AMENDMENT OF SOLICITATION/MODIFICATION OF CONTRACT			1. CONTRACT ID CODE	PAGE OF PAGES	
			J	1	6
2. AMENDMENT/MODIFICATION NO. 0001	3. EFFECTIVE DATE 16-Jan-2004	4. REQUISITION/PURCHASE REQ. NO. W38XGR-3328-3726		5. PROJECT NO.(If applicable)

14. DESCRIPTION OF AMENDMENT/MODIFICATION (Organized by UCF section headings, including solicitation/contract subject matter where feasible.) This solicitation for Upper Camp Creek Interceptor North, DeSoto County, Mississippi (Project No. 4-B), scheduled to open January 29, 2004 at 2:30 P.M. is amended as follows: 1. Section 00100- Solicitation Contract Form. Pages 3 through 5 are deleted in their entirety and the attached Pages 3 through 5 are substituted therefor. (Please Note: Item 14 has been added) (Continued on next page)					
Except as provided herein, all terms and conditions of the document referenced in Item 9A or 10A, as heretofore changed, remains unchanged and in full force and effect.					
15A. NAME AND TITLE OF SIGNER (Type or print)			16A. NAME AND TITLE OF CONTRACTING OFFICER (Type or print)		
			TEL: _____ EMAIL: _____		
15B. CONTRACTOR/OFFEROR	15C. DATE SIGNED	16B. UNITED STATES OF AMERICA		16C. DATE SIGNED

BEDDING / BACKFILL DETAIL

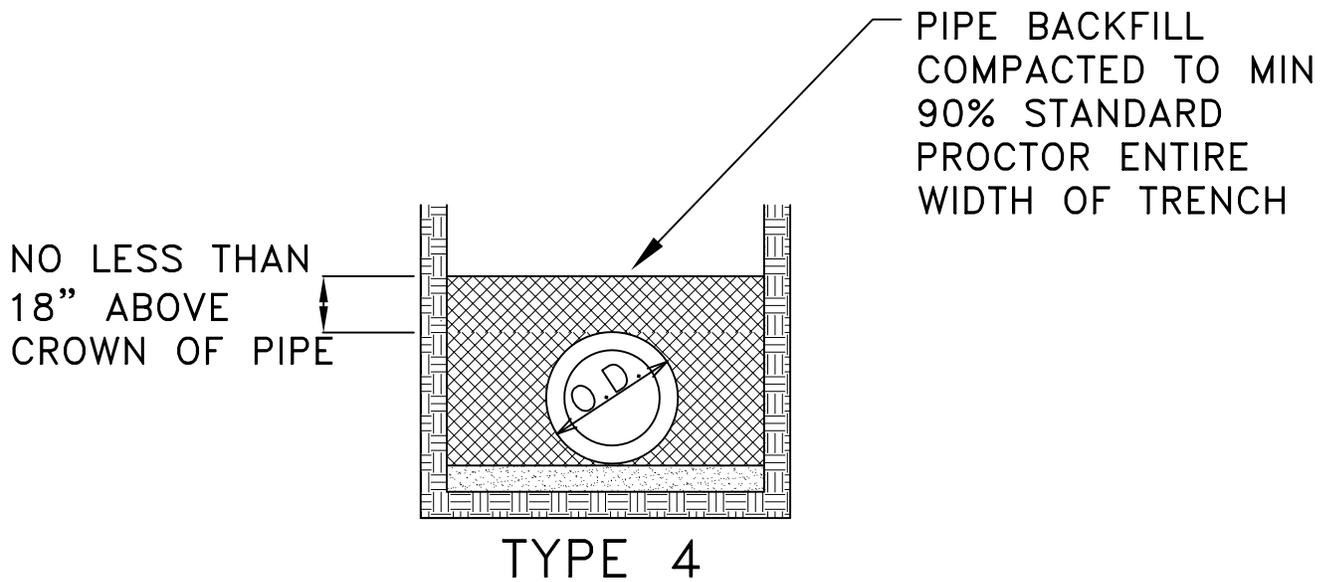
7. Section 02560: Add Bedding Detail sketch to the end of this section.

1. Section 02560 of the Specifications calls for the foundation to be #57 stone where indicated on the drawings. There is no bedding or foundation detail shown.

2. Section 02560, paragraph 2-08 says bedding and backfill material to 1' above the top of the pipe. The bedding material shown on the specifications is a mixture of two parts #467 stone and 1 part sand. Backfill material is material with 30 to 100% passing the #10 screen. There is no detail showing where the bedding material stops and the backfill material begins. Normally the pipe is completely encapsulated in #57 stone when it is placed under these conditions and we think the manufacture will agree.

7. Section 02560, paragraph 3-15 defines backfill. It states the backfill starts 18" above the top of pipe. This is in conflict with the select backfill spec that calls for 12" above the top of the pipe.

See Amendment #1 for Bedding/Backfill detail.

See Amendment #1 for Bedding/Backfill detail. MDOT #57 crushed limestone may be used in lieu of the #467 specified.

See Amendment #1 for the Bedding/Backfill detail. Granular stone backfill is to extend to 18" above the top of the pipe. Above 18", native material may be used, if suitable.

PIPE BEDDED MATERIAL PER
SPECIFICATIONS TO DEPTH OF $\frac{1}{8}$ PIPE
DIAMETER, 6" MINIMUM. BACKFILL
COMPACTED TO TOP OF PIPE.
(MINIMUM 90% OF STANDARD
PROCTOR, AASHTO T-99)
